TOWN OF
BRECKENRIDGE

Planning Commission Meeting Agenda

Planning Commission Work Session Staff Report

- Subject:** South Gondola Lot Parking Structure (Work Session)
(Town Project Work Session – PL-2019-0173)
- Proposal:** Construct a new public parking structure located on the existing South Gondola Lot. The project will provide 688 parking spaces within the structure, plus 255 exterior surface parking spaces, bicycle parking and public restrooms. The proposed parking structure totals 249,984 sq. ft. and will provide 413 additional spaces beyond the South Gondola Lot’s current capacity.

SK-1

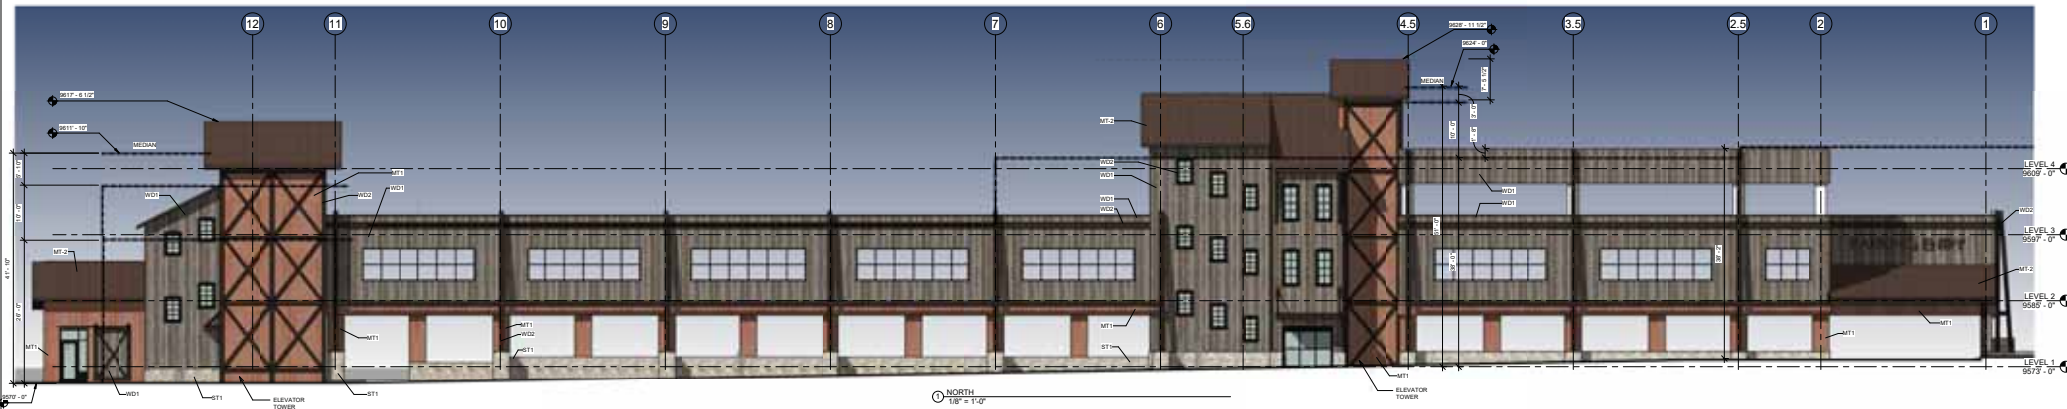
The height of the tallest portion is 44'8 5/8" to the roof of the northeast stair tower, best illustrated on sheet SK-1, measured from the mean to the finished grade below. This exceeds the building height recommended in the land use guidelines by more than one and one-half (1/2) stories but less than two stories. Staff believes since the façade is adjacent to the river the recommended height is two stories. Staff finds the three story recommendation starts to apply in western half of the parcel that is substantially setback from the river. Based on this assumption staff believes the proposed height warrants negative twenty (-20) points under Policy 6/R.

Staff acknowledges negative twenty (-20) points is a lot to overcome but believes some modifications to the building height are possible and could shave a significant amount of negative points. If the structure were to be reduced to below 44' to the mean, negative fifteen (-15) points would be assigned. If it were reduced further to below 38' then negative ten (-10) points would be earned.
